# Response to Submissions and Amendment Report

*15A/B Moseley St, & 25-31 Donald St, Carlingford*

February 2026

Prepared for: Capio Property

Figure 3 Shadow Diagram 9am – 3pm 21 June

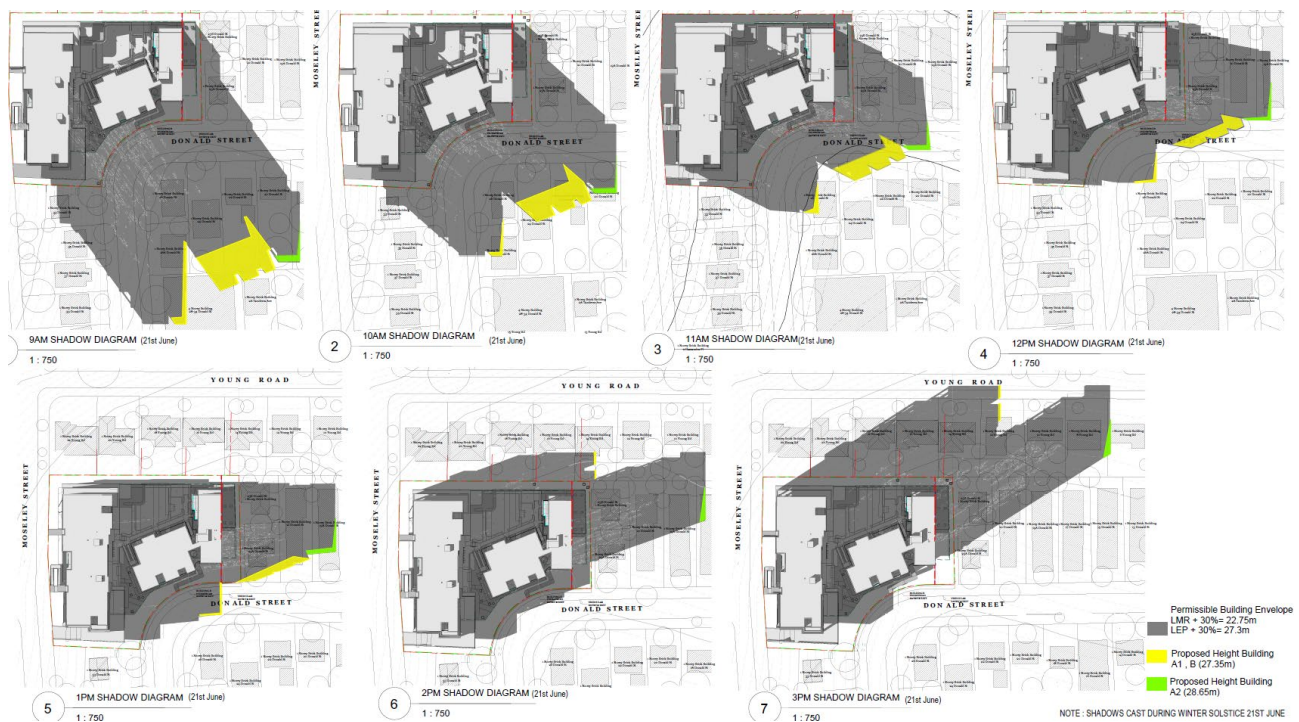
Additionally, and as requested by the DPHI, the Architectural Design Report has been updated to include an solar analysis to include consideration of how the overshadowed properties on Donald Street would be affected if they are developed under the LMR.

Figure 3 below provides a comparison of building shadows between a permissible building envelope and the proposed building envelope. Grey shadows reflect the permissible building envelope (fully compliant height), while the yellow represents additional shadows cast by the proposed envelope of Building A1 and B, and green for Building A2. This figure is based on the winter solstice on 21 June.

Shadow impacts cause by the non-compliant building height generally only impacts existing dwellings at 9am – 11am. By 12pm, there remains only a small slither of impact on 26 Donald Street, isolated to the front north-east corner of the building. A further analysis of each property on Donald Street has been provided.
